Work Order ID 140434

Item Name: Quick Release Heli-Utility-Basket™ Long, HD Lid, Spacepod™/Squirrel Check Comp.

DART SERVICE INSTRUCTION

TO AMEND INSTALLATION INSTRUCTIONS D350-607-3 Rev.D,
INSTALLATION INSTRUCTIONS D350-607-4 Rev. C AND
INSTRUCTIONS FOR CONTINUED AIRWORTHINESS ICA-D350-607 REV. 6

FIGURE 1: INSTALLATION OF D4775-041 FWD STRUT

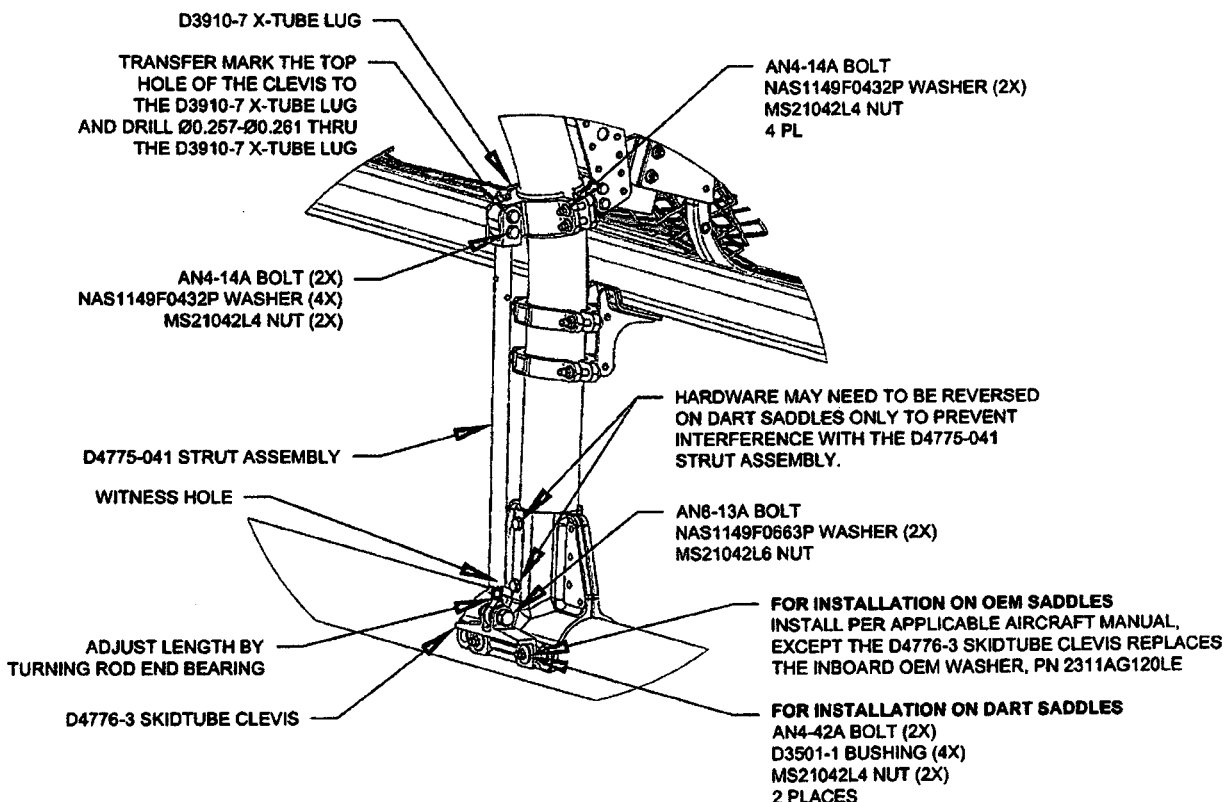
- 3.1 Substitute the Forward Lower D3910-5 X-Tube Lug with the D3910-7 X-Tube Lug as shown in Figure 1.
- 3.2 Install the forward D4775-041 Strut Assembly. Transfer mark from the upper hole on the clevis of the D4775-041 Strut Assembly to the D3910-7 X-tube Lug and drill thru the lug $\varnothing 0.257$ - $\varnothing 0.261$ as shown in Figure 1. Touch up chemical conversion coating per MIL-DTL-5541. Check the witness holes located at the bottom end of the D4775-041 Strut Assemblies to ensure that the thread from the rod end extends past the witness hole.
Torque MS21042L4/-4 nuts to 50-70 in-lbs (5.7-7.9 N-m). Torque MS21042L6/-6 nuts to 160-190 in-lbs (18.1-21.5 N-m).
- 3.3 Complete the installation in accordance with Installation Instructions D350-607-3 Rev. D or D350-607-4 Rev. C.
